SERVICE BULLETIN

NACELLE - EXHAUST - THRUST REVERSER CASCADE - IDENTITY OF - CATEGORY CODE 8 -
MOD.NAC-78-0027

V2500-NAC-78-0027

Deflector Box Label Location Left and Right Hand Nacelle
Fig.1

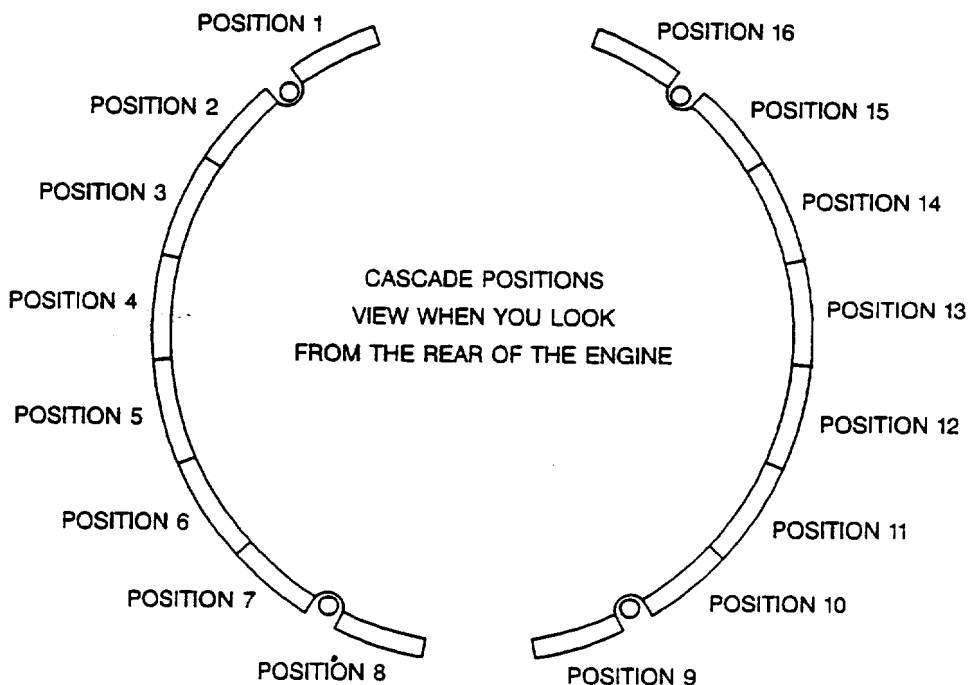
Install cascade position labels on thrust reverser cascade assemblies to help in removal and installation tasks.

- (a) Clean the area of the deflector box or blank box with MIBK where label will be installed.
- (b) Install the appropriate position label on the box. (Refer to Figures 1 and 2.)

LABEL DASH NO.	POSITION LABEL LOCATION	
	LH NACELLE POSITION	RH NACELLE POSITION
-501	2, 6, 15	2, 11, 15
-503	1	1
-505	16	16
-507	3, 7	3
-509	14	10, 14
-511	4	4
-513	13	13
-515	10	6
-517	11	7
-519	8	—
-521	—	9
-523	5, 12	5, 12
-525	9	—
-527	—	8
